UNITED STATES PATENT AND TRADEMARK OFFICE

Office Action Summary	Application No. 10/593,679	Applicant(s) EVERTZ, EGON	
	Examiner BRANON C. PAINTER	Art Unit 3633

DETAILED ACTION

Reproduced from Muller

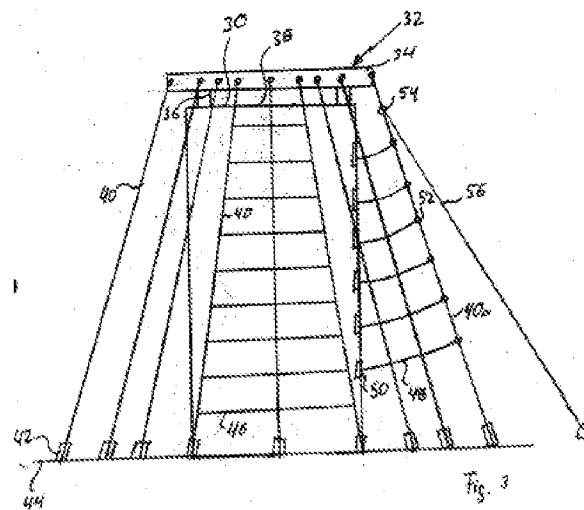
11. Claims 1 and 17 are rejected under 35 U.S.C. 102(e) as being anticipated by Muller (DE20302249 – English translation).
12. Regarding claim 1, Muller discloses a building protection system having all of the applicant's claimed structure, including:
 - a. Wire cables maintained under tension (40, Fig. 3).
 - b. The cable ends anchored in a clamping body that has a guide shaped such that the reaction force of the clamping body increases with an increase in tensile force (42; p. 8, 1-3).

Reproduced from Jackson

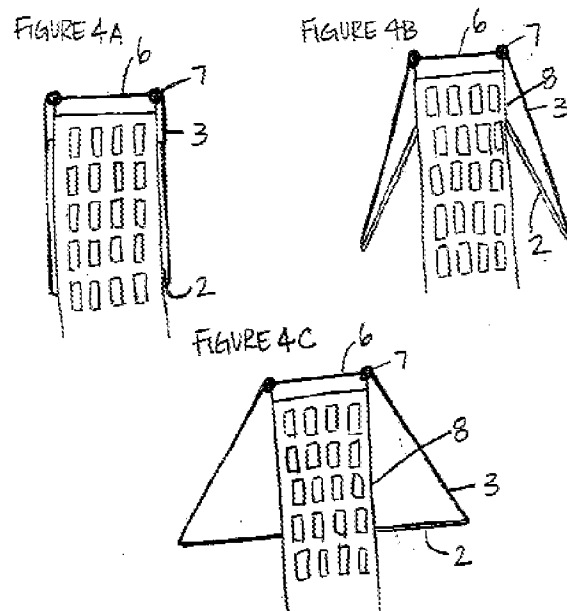
- a. Wire cables maintained under tension (3, Figs. 4).
- b. The cable ends anchored in a clamping body that has a guide shaped such that the reaction force of the clamping body increases with an increase in tensile force (connection point of 2 and 3).

16. Regarding claim 10, Jackson discloses wire cables capable of being accommodated at the roof (3 stored in 7; [0028]).
17. Regarding claim 11, Jackson discloses a frame structure outside the building (6) that offers a surface in which the wire cables can be accommodated (7).
18. Regarding claim 12, Jackson discloses profiles mounted on the roof that form cavities in which wire cables can be accommodated (7).

19. Regarding claim 13, Jackson discloses a clamping body that is translationally movably connected to the building (2; [0028]).
20. Regarding claim 14, Jackson discloses profiles (2) mounted on facades (8) and that can be rotated, swung, or moved translationally (2).

Reproduced from Stubler

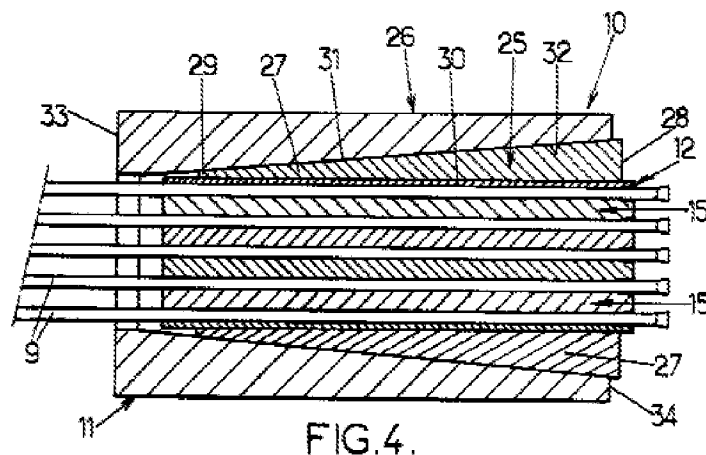
- c. Stubler discloses a system for connecting a cable to a ground structure that includes a clamping body (26, Fig. 4) with a guide (25) having a peripheral surface that narrows progressively in the direction of the tensile force.

- d. At the time of the invention, it would have been obvious to a person of ordinary skill in the art to replace the clamping body of Muller with the clamping body as taught by Stubler, as the two clamping bodies are art-recognized equivalents.

- e. The examiner further notes that it would have been obvious to a person of ordinary skill in the art to replace the clamping body of Muller with the clamping body as taught by Stubler, since the frustoconical body-guide relationship ensures a strong connection between the cables and clamping body.

30. Regarding claim 3, Muller/Stubler as modified above discloses a building protection system with conical clamping body, with Stubler further disclosing an inner guide surface material that is harder than the wire cable material (Fig. 4).

- a. The examiner notes that for Stubler to function as intended, the inner guide surface must necessarily be harder than the wire cable, because if it wasn't the tensioned cables would bend and distort the guide, and eventually pull out of the guide entirely.

Reproduced from Stubler (amended)

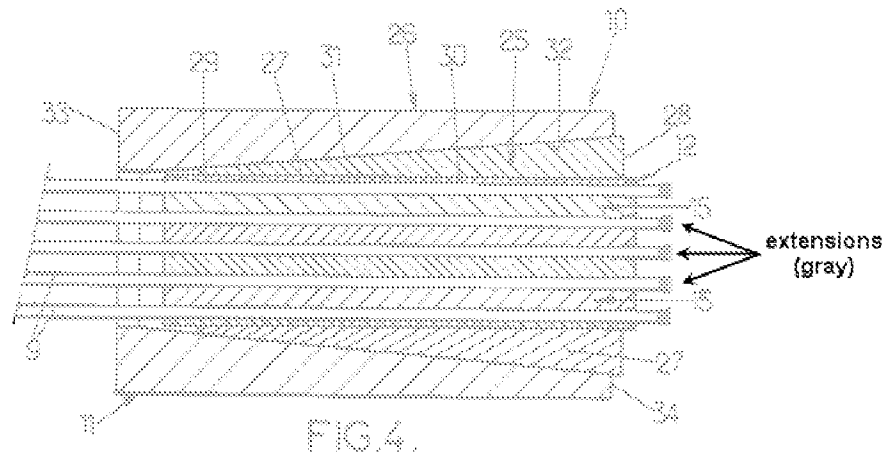
34. Regarding claim 7, Muller/Stubler as modified above discloses a building protection system with conical clamping body, with Stubler further disclosing wire cable extensions comprising strip-like bodies (amended Fig. 4).

- a. The examiner notes that the gray portions in Fig. 4 are considered the extensions of the wire.

35. Regarding claim 8, Muller/Stubler as modified above discloses a building protection system with conical clamping body, with Stubler further disclosing extensions having a continuous broadening (amended Fig. 4).
